DEVELOPMENT DETERMINATION PANEL MEETING

WEDNESDAY 28 AUGUST 2019

ITEM 3.1 DA2019/0055 - 9 MINKARA ROAD, BAYVIEW - CONSTRUCTION OF A DWELLING HOUSE

DEVELOPMENT APPLICATION ASSESSMENT REPORT

ELEVATIONS
SOUTH & EAST

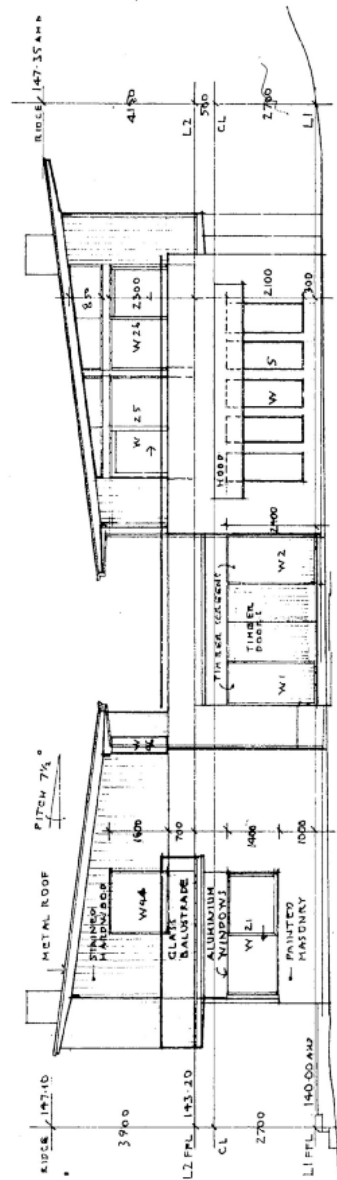
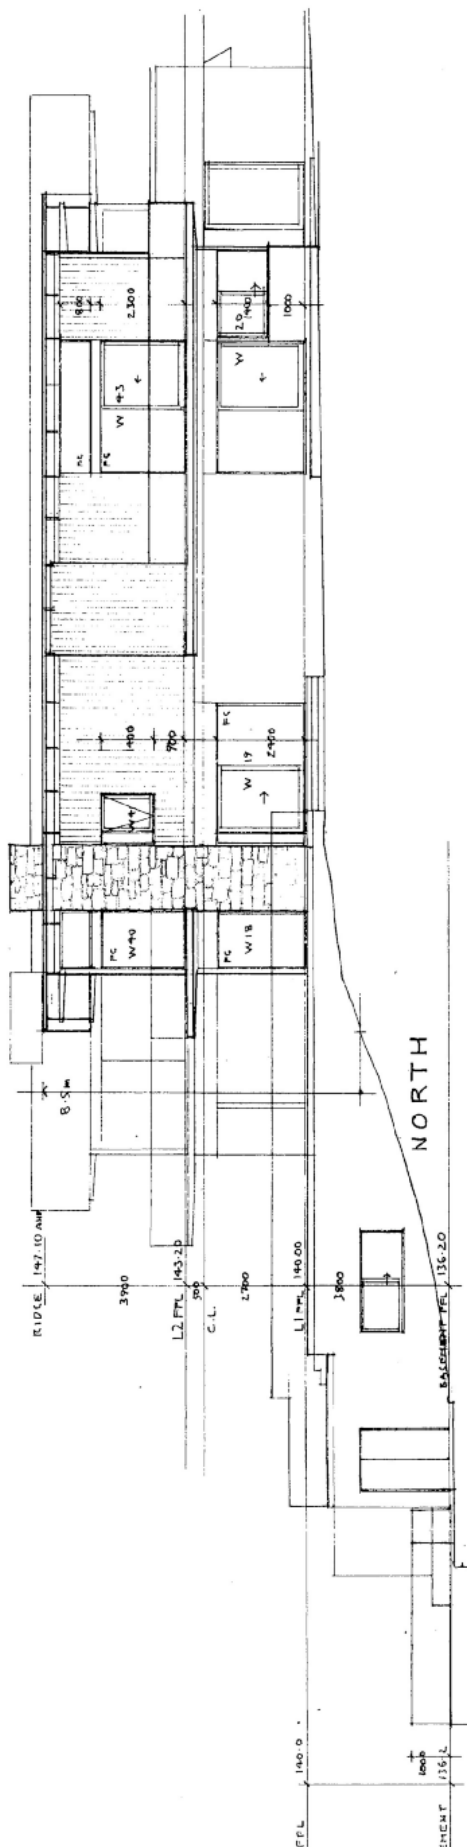
The proposal does not comply with the maximum building height development standard. An assessment of the plans provided shows that the chimney on the South Elevation has a maximum height of 9.9m above natural ground level, which is highest point of the building. The location of non-compliance with the height is where the land begins to naturally slopes away. The southern elevation chimney will be constructed of natural sandstone and the building will be colours and materials that will blend in with the natural environment of the site.

The height variation is largely limited to minor roof elements and can be seen on the South Elevation on drawing 2416 - DA06A.

01 SOUTH ELEVATION 1:100

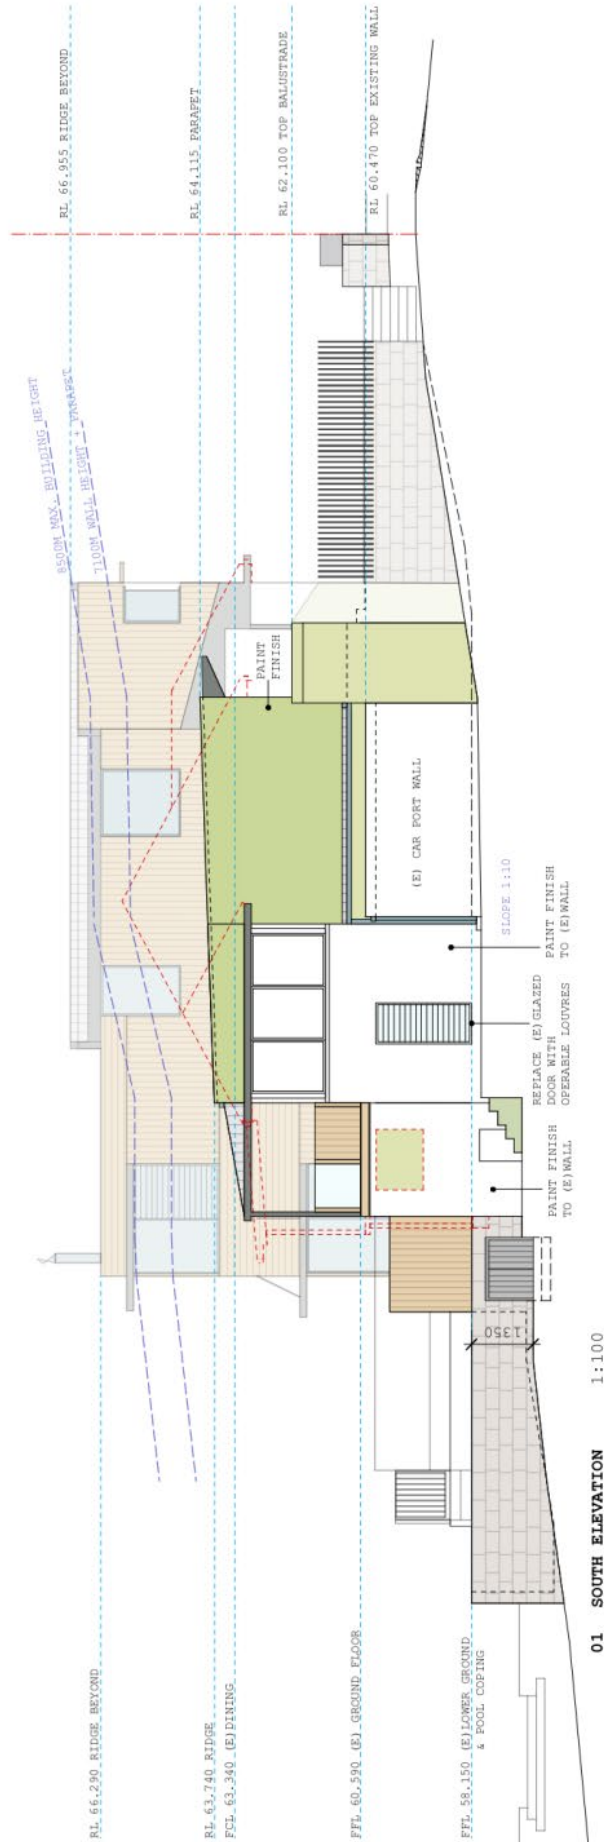
- The southern elevation parapet (coloured green on drawing DA09) above the Existing Dining and Existing Bedroom on the Ground Floor Plan (drawing DA05), is to be made horizontal, stepping down as required from RL64.115 at the eastern end to RL63.740 at the western end.

- Window W.25 (south facing from Masterbed 1 on the new upper level) is to have a minimum sill height of 1.3m above finished floor level.
- South facing windows W.26 and W.27 are to have minimum sill heights as shown on the approved drawing DA11 (1.4m for W.26 and 1m for W.27).
